Landscape Referral Response

Application Number:	DA2018/1514
Date:	11/04/2019
Responsible Officer:	Lashta Haidari
Land to be developed (Address):	Lot 100 DP 1015283 , 145 Old Pittwater Road BROOKVALE NSW 2100

- Landscape area forward of the car-park opposite Warringah Golf Club:
DA2018/1514

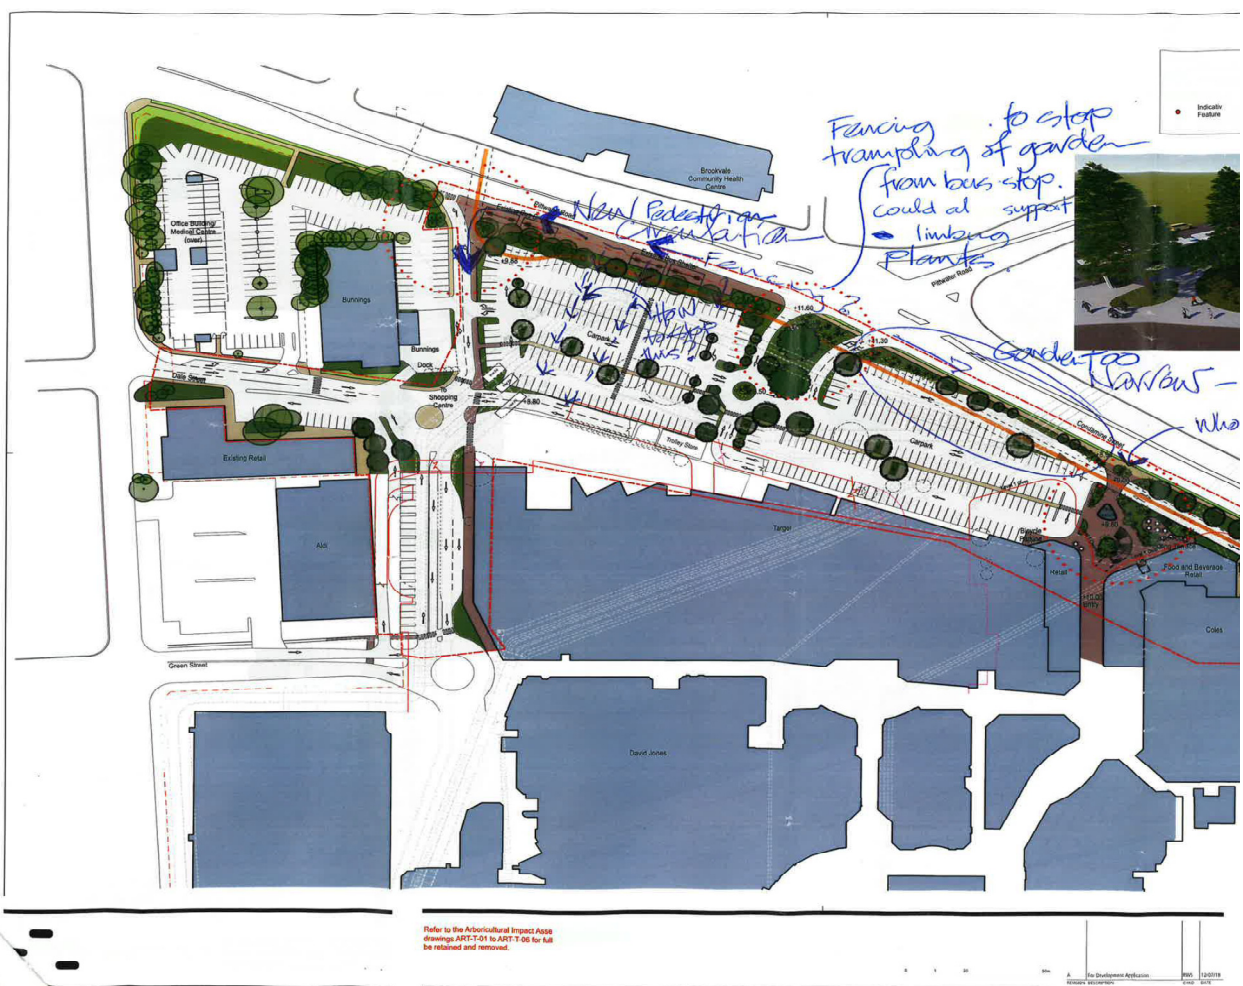
The plans indicate reduction in the width of the landscape area with minimal landscape buffer to the carpark. The resultant area will be dominated by hard surfaces and cars. This is considered to be a poor response to the streetscape along a major arterial road. Insufficient width is provided to enable suitable planting to screen the car-park and integrate the bulk and scale of the development into the streetscape.
